# Access Compliance Report

## Public Rights-of-Way

### (Curb Ramps)

Intersection ID: 42931	Main Street: BRAY_DR	Cross Street: HOLLY_PARK_DR	Location: S
ADA ID: 2F5C713BF44E	Ramp Type: PerpDiag	Initial Pass/Fail: Fail	Overall Compliance: No
Codes/Mitigation Info/Possible Solution		Field Measurements/Component Compliance	
		Severity Score: 10

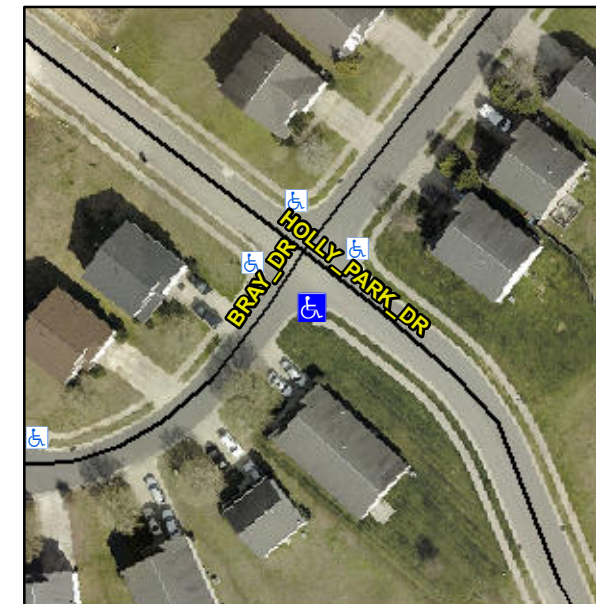
**Not Found, R304.5.1, R304.5.3**

Compliance	Description	Data	Compliance	Description	Data
N/A	Ramp Length (in)	48.0	Yes	Ramp Slope (%)	5.0
No	Ramp Width (in)	39.0	No	Ramp XSlope (%)	3.7
N/A	Flare Type LT	N/A	N/A	Flare Type RT	N/A
N/A	Flare Slope LT (%)	N/A	N/A	Flare Slope RT (%)	N/A
N/A	Flare Traversable LT?	N/A	N/A	Flare Traversable RT?	N/A
N/A	Landing Length (in)	N/A	N/A	DWS Provided?	N/A
N/A	Landing Width (in)	N/A	N/A	DWS Contrast?	N/A
N/A	Landing Slope (%)	N/A	N/A	DWS Length (in)	N/A
N/A	Landing X Slope (%)	N/A	N/A	DWS Full Width?	N/A
N/A	Landing Curb? (Y/N)	N/A	N/A	DWS Offset (in)	N/A
N/A	Shared Landing?	N/A			
N/A	Gutter Ponding?	N/A	N/A	Gutter Slope (%)	N/A
N/A	Gutter Lip Ht (in)	N/A	N/A	Gutter X Slope (%)	N/A
N/A	Painted X Walk1?	No	N/A	Painted X Walk2?	No
	X Walk 1 Direction	To NE		X Walk 2 Direction	To NW
N/A	X Walk 1 Width (in)	N/A	N/A	X Walk 2 Width (in)	N/A
	X Walk 1 Slope (%)	6.1		X Walk 2 Slope (%)	2.4
	X Walk 1 X Slope (%)	0.2		X Walk 2 X Slope (%)	3.8

**Remove & Replace Curb Ramp With Two New Directional Ramps or Equivalent.**
